Fuel Cell System for Transportation – 2005 Cost Estimate

Independent Review October 2006

Subject: Independent Review Team Report

Figure 1: PEM Fuel Cell System Model developed by Argonne National Laboratory (Carlson et al. 2005)

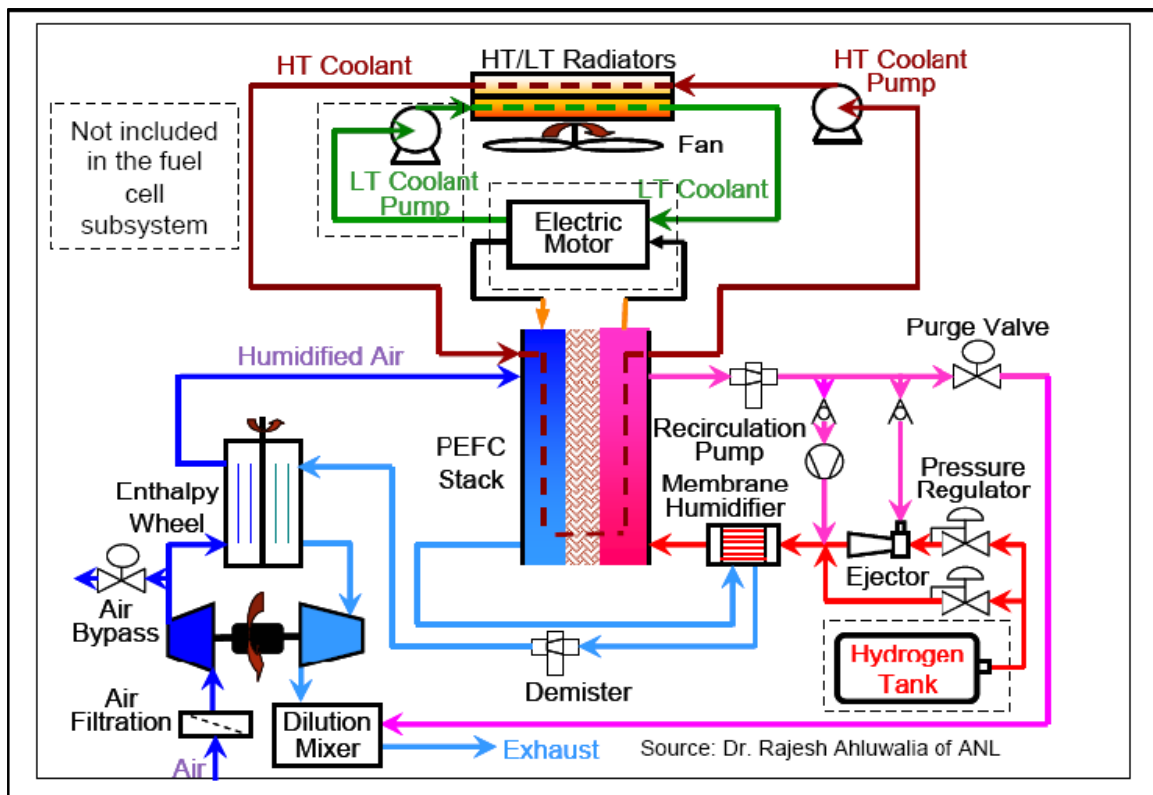
Interviewees believed the BOP costs for the fuel cell power plant were consistent with their understanding; however, they expressed concerns that the specific system or BOP components differed from their experience and that their final power plant designs for commercial production would be different from the ANL model used by TIAX. They also expressed caveats concerning the possible BOP cost increases to accommodate application issues such as:

- Cold start
- Durability – reliability of BOP components with moving parts (enthalpy wheel) and humidification approach
- Operability – transient response, hot day operation, hill climbing, air conditioning.

Some BOP components have not been fully demonstrated. Industry reported to the Team that the compressor-expander was based on data from separate devices and the combined device had not been demonstrated. The enthalpy wheel was considered bulky and its ultimate reliability was questioned. Discussions with industry identified alternative technologies that would replace the compressor-expander and possibly the enthalpy wheel.

Predictably, the ANL model was accepted by some of the fuel cell manufacturers, but not by all. Fuel cell integrators have their own fuel cell system designs based on their proprietary technologies. The configuration of the fuel cell system has a strong influence on the cost analysis, since it will influence the component performance specifications (e.g., inlet and outlet pressures, temperatures, flow-rates, and compositions) and establishes the BOP components. The ANL model may be too focused on one PEM system or one BOP component manufacturer. Industry representatives suggested alternative system designs and recommended that a study be undertaken to identify the optimum system for PEM fuel cells.

The PEM fuel cell system design should be reconsidered. Industry suggested alternative system designs and a study to identify the optimum system for PEM fuel cells. Any future models should be developed with broader industry and national laboratory input.
